Village of Winnetka

Design Review Board/Sign Board of Appeals Regular Meeting

TO: DESIGN REVIEW BOARD
FROM: CHRISTOPHER MARX, AICP, ASSOCIATE PLANNER
DATE: JANUARY 13, 2023
SUBJECT: 551-553 CHESTNUT STREET - EVEREVE - CERTIFICATE OF APPROPRIATENESS (AMENDED CASE NO. 22-26-DR)

TO: DESIGN REVIEW BOARD
FROM: CHRISTOPHER MARX, AICP, ASSOCIATE PLANNER
DATE: JANUARY 13, 2023
SUBJECT: 310 GREEN BAY ROAD – NORTH SHORE COUNTRY DAY SCHOOL -
CERTIFICATE OF APPROPRIATENESS (CASE NO. 23-01-SU)

New Storefront Design | Signage

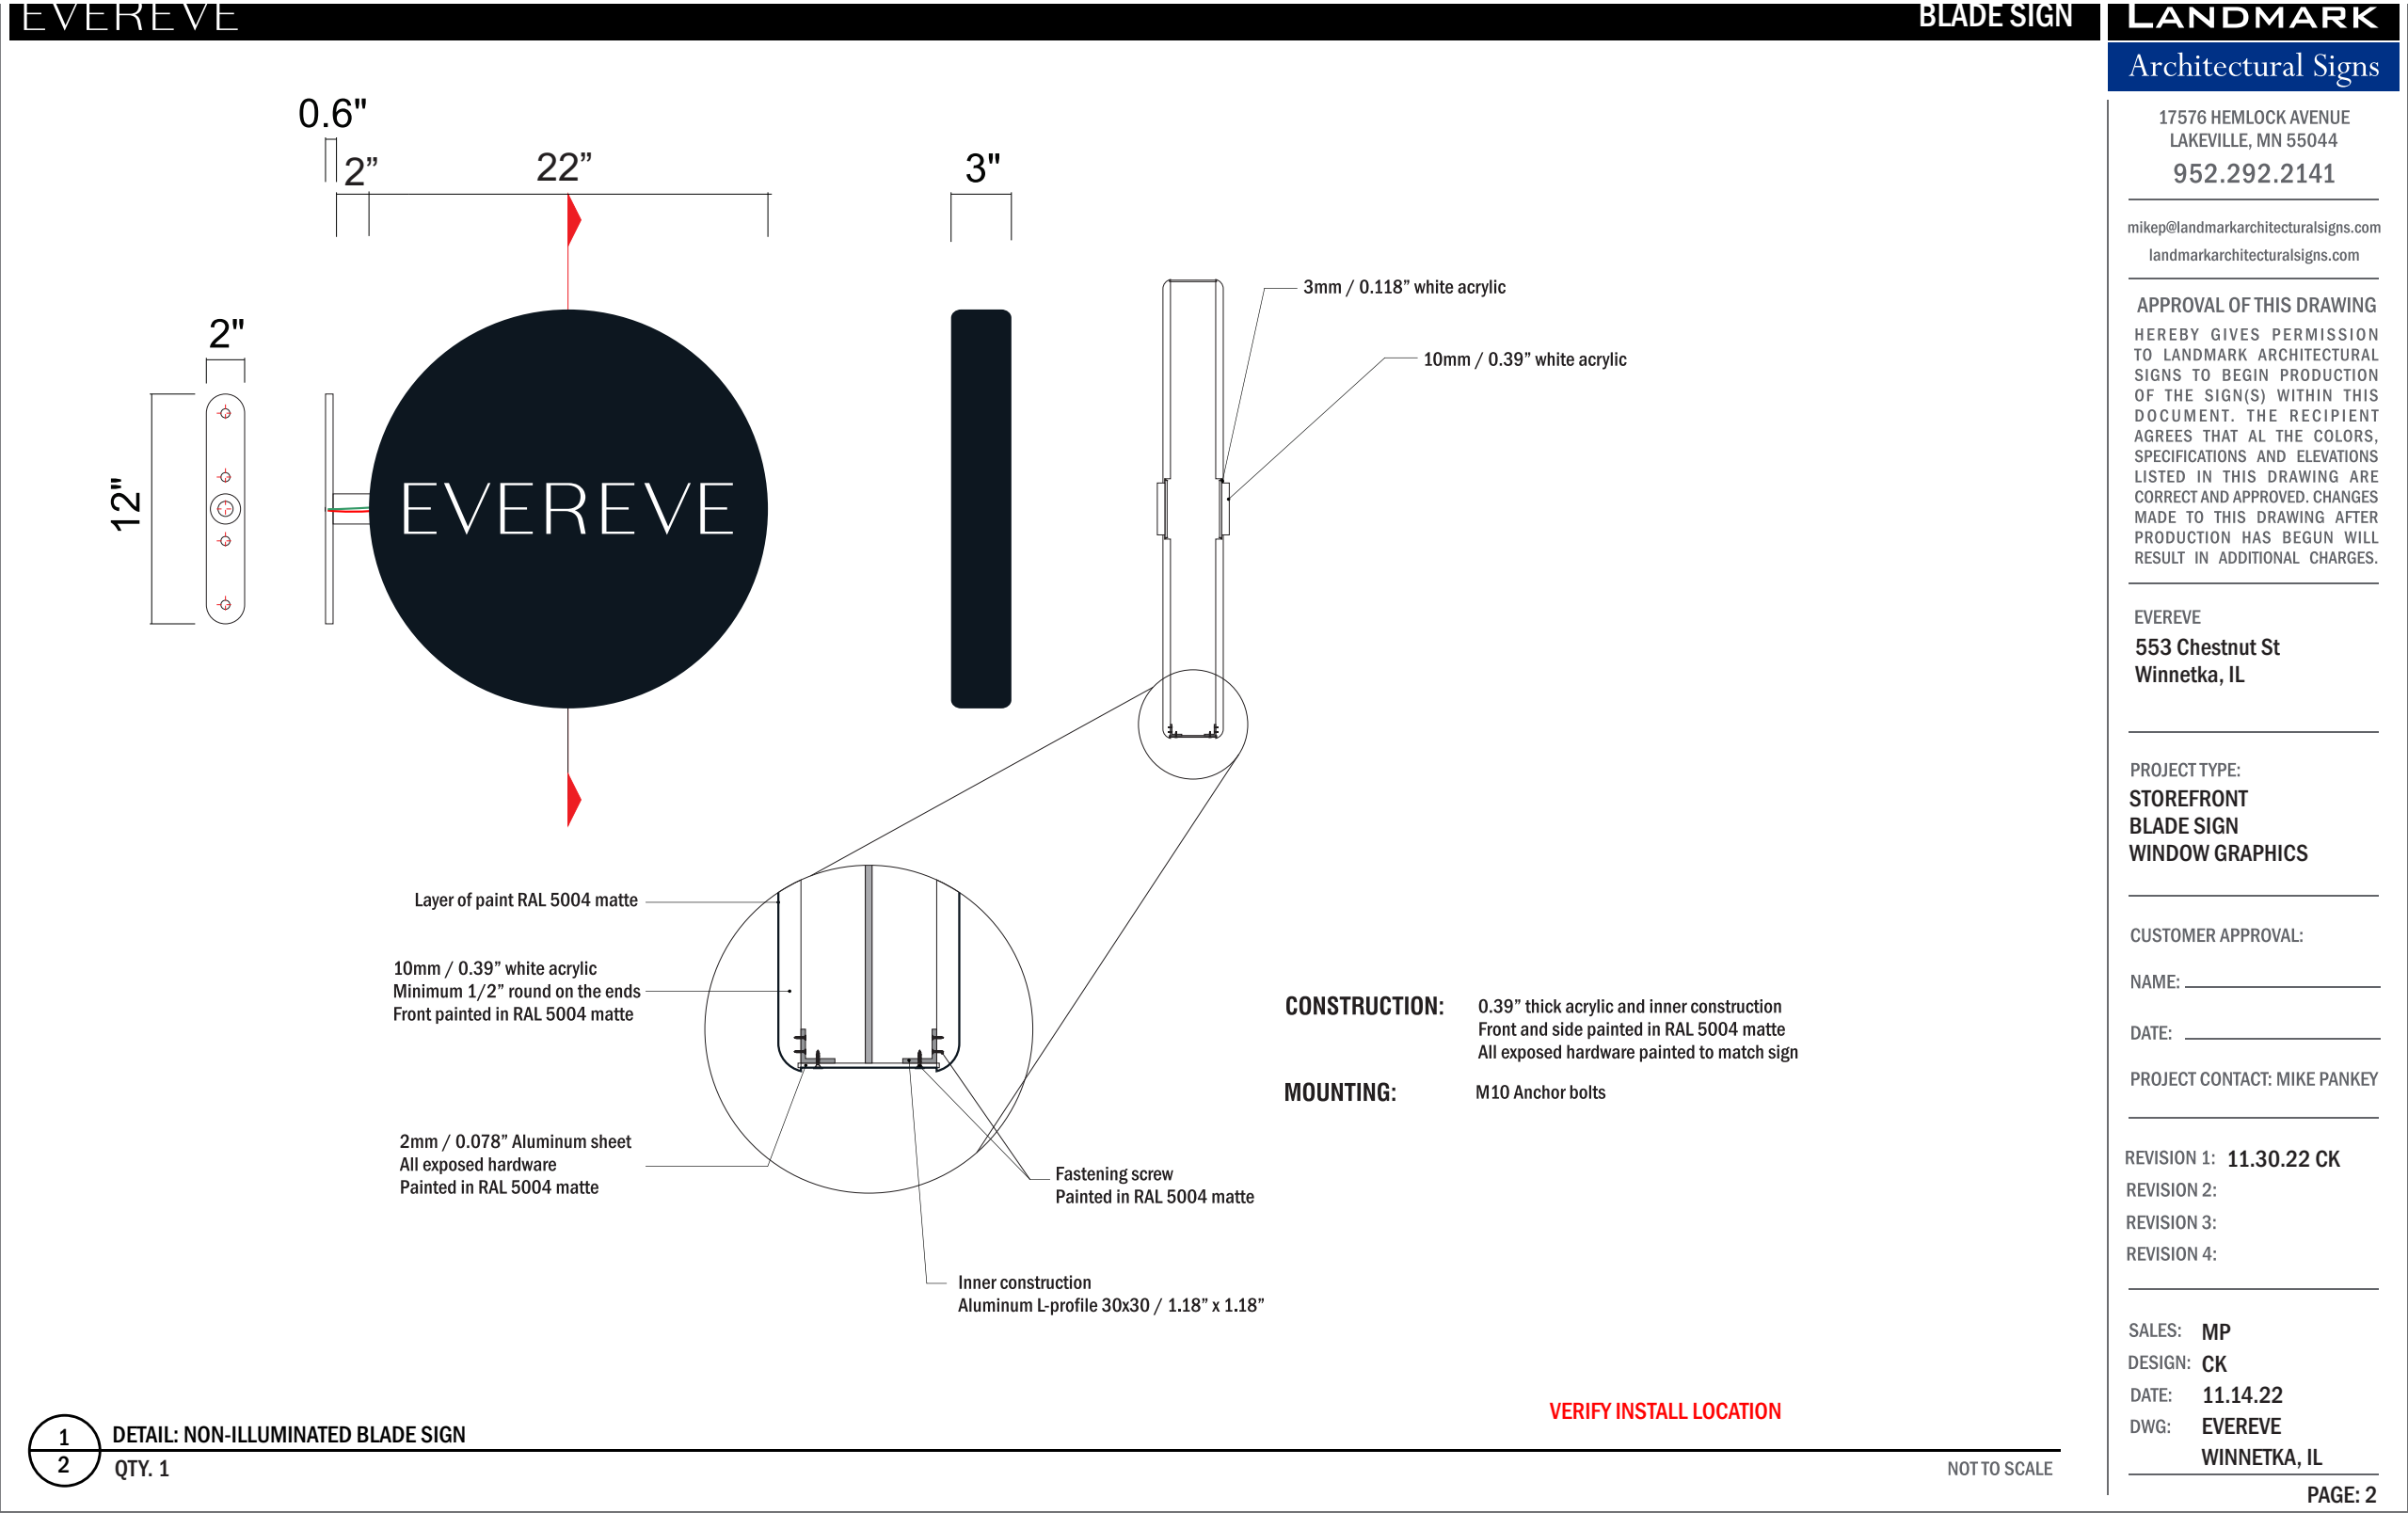
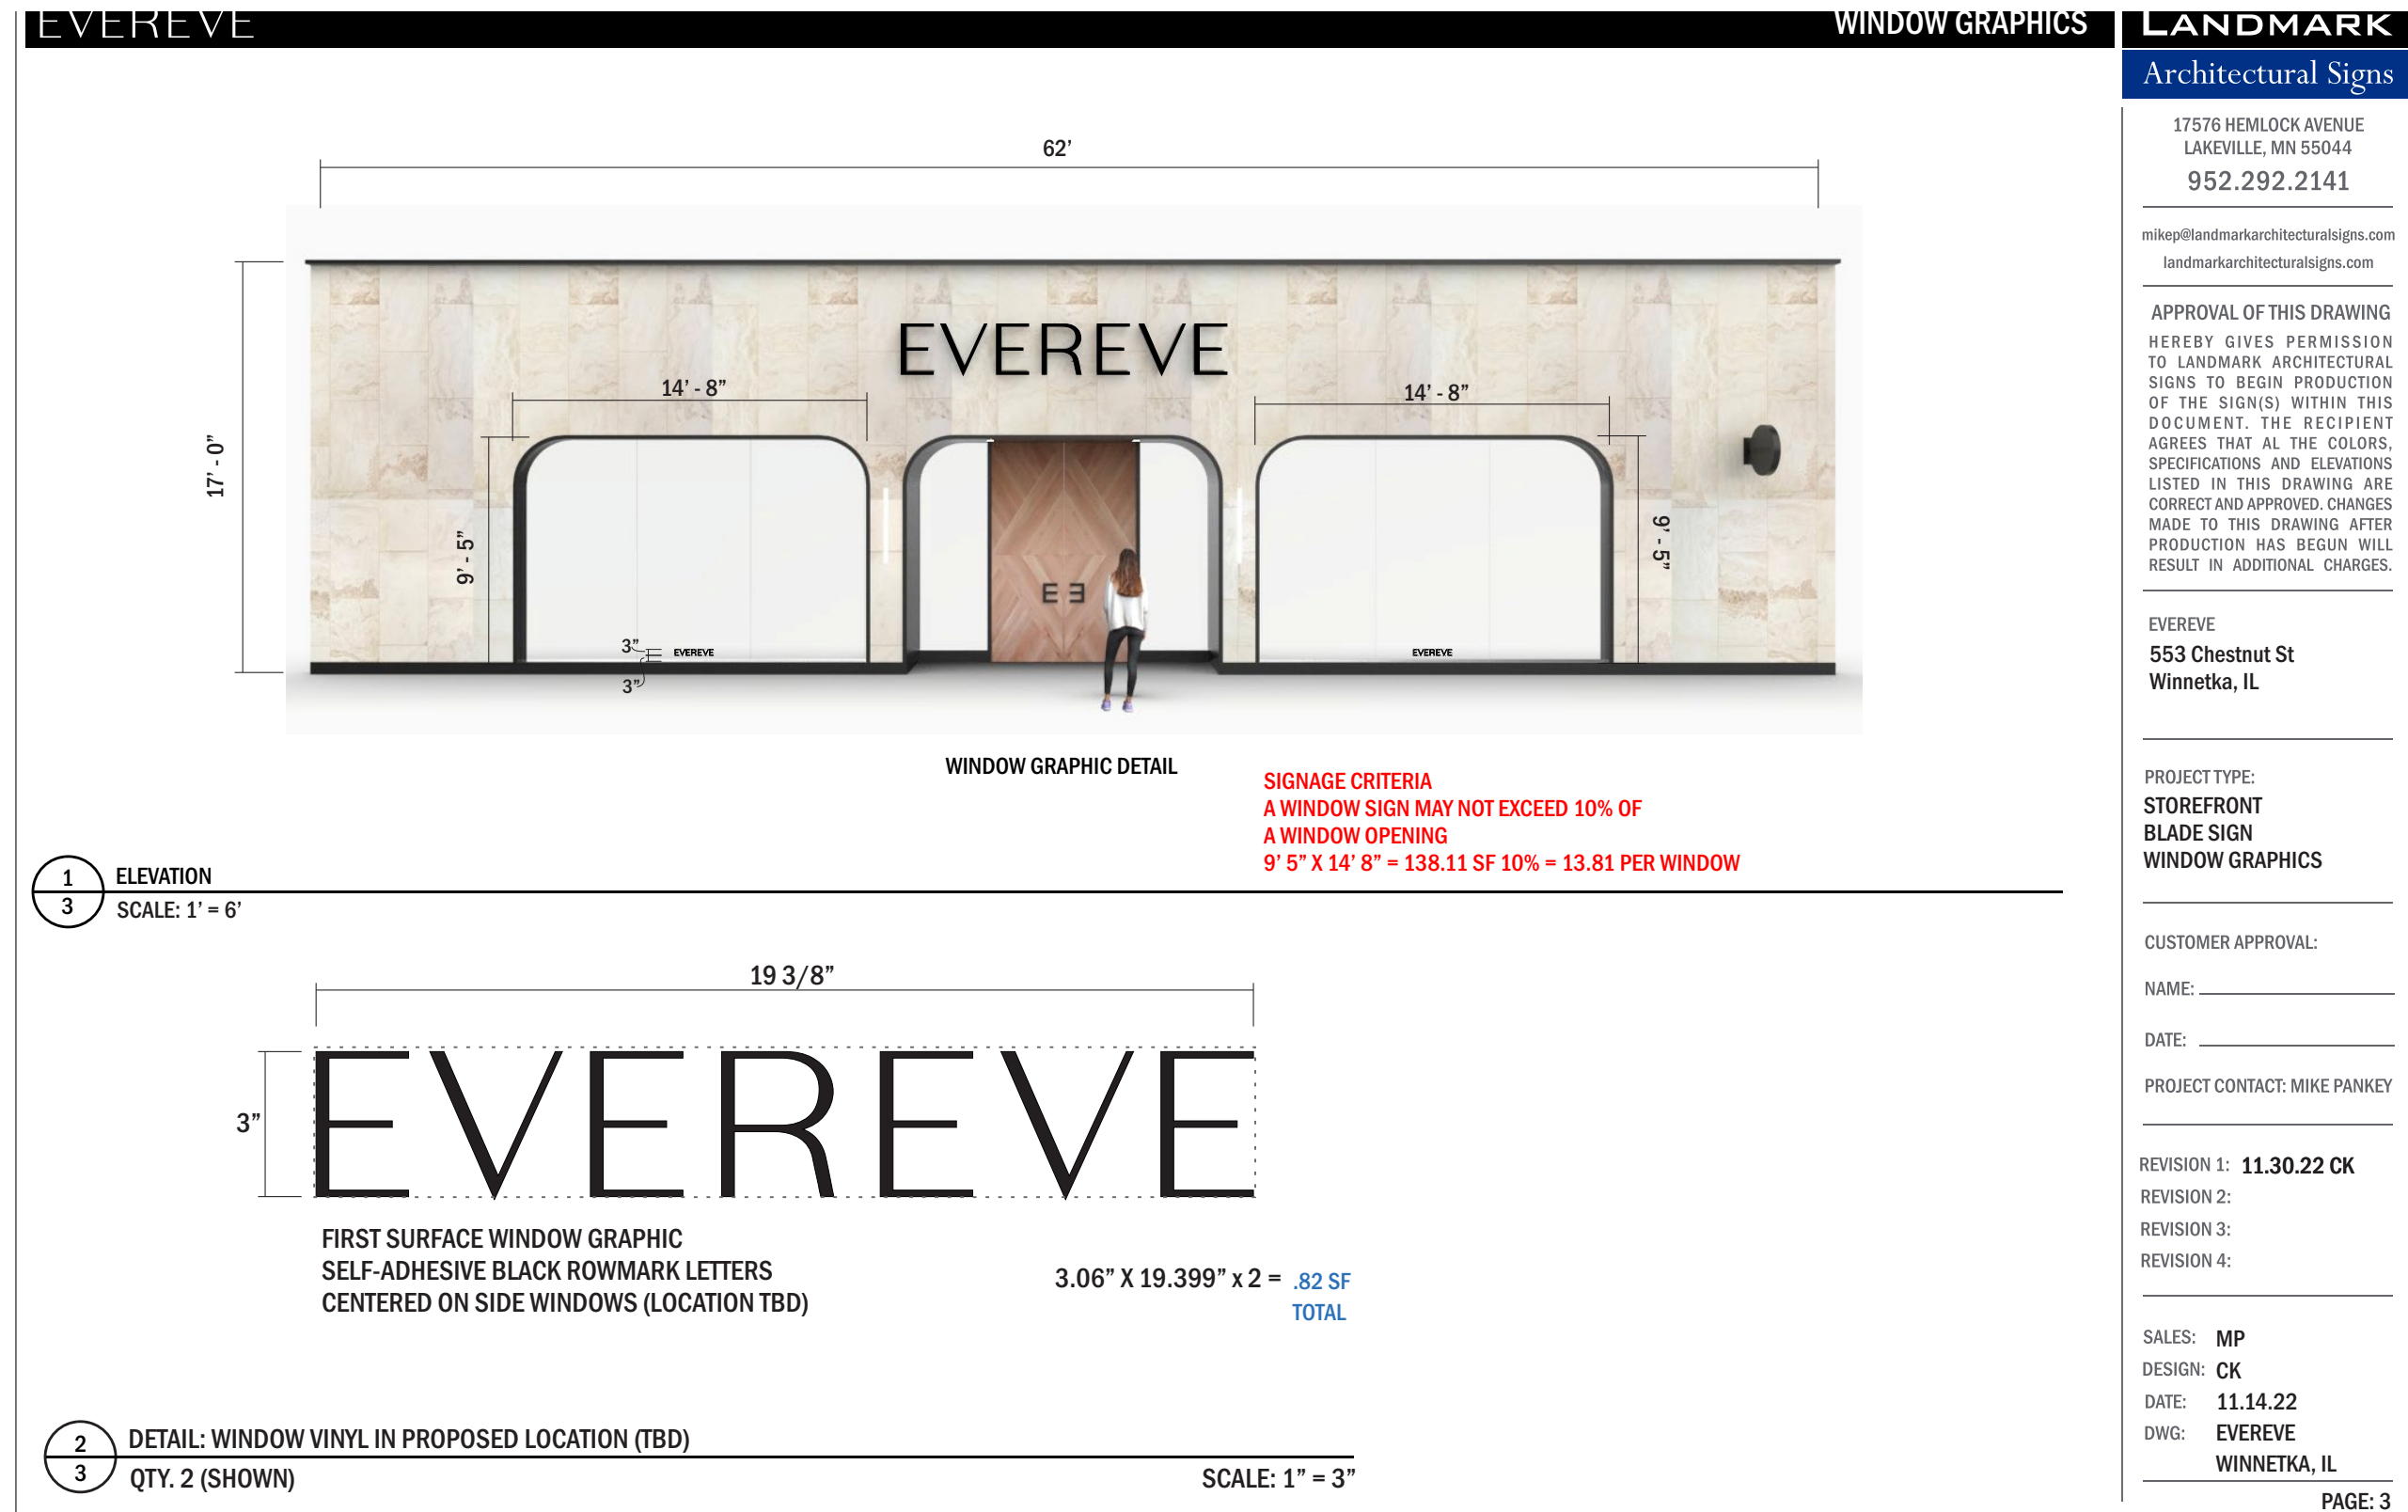
3
4 Ms. Moor described the proposal as a huge departure from the existing streetscape. Mr. Konstant agreed
5 with Ms. Moor's comment and commented the applicant's Lake Forest location is more in keeping with
6 the street's character. Ms. Ihle explained the reasoning behind their Lake Forest location design. She
7 added the building height would not change and a more open to the storefront feel would be created.
8 Ms. Ihle also described the reasoning behind the material selection as well as the amount of the
9 storefront's damage which required curb replacement. Mr. Marx identified the height on page 18.

In response to the comments at the December 19 DRB meeting, the Applicant has provided the attached revised plans (see Attachment A1). The primary changes to the plans include: (a) an adjustment to the size of the pin-mounted lettering wall sign; and (b) three alternative options for the storefront surface material. At the January 19 meeting, the Applicant will present and discuss the revised plans with the Board.

The proposed sign has been reduced in size from 28.06 square feet in area and 13.49 feet in width to 16.19 square feet and 10.25 feet in width. The proposed sign complies with the Sign Code. The change was made to accommodate a sign that was more horizontally aligned with the main entrance opening. Figures 1 and 1B on the following page compare the previous and revised elevation renderings of the storefront to illustrate the changes to the wall sign.
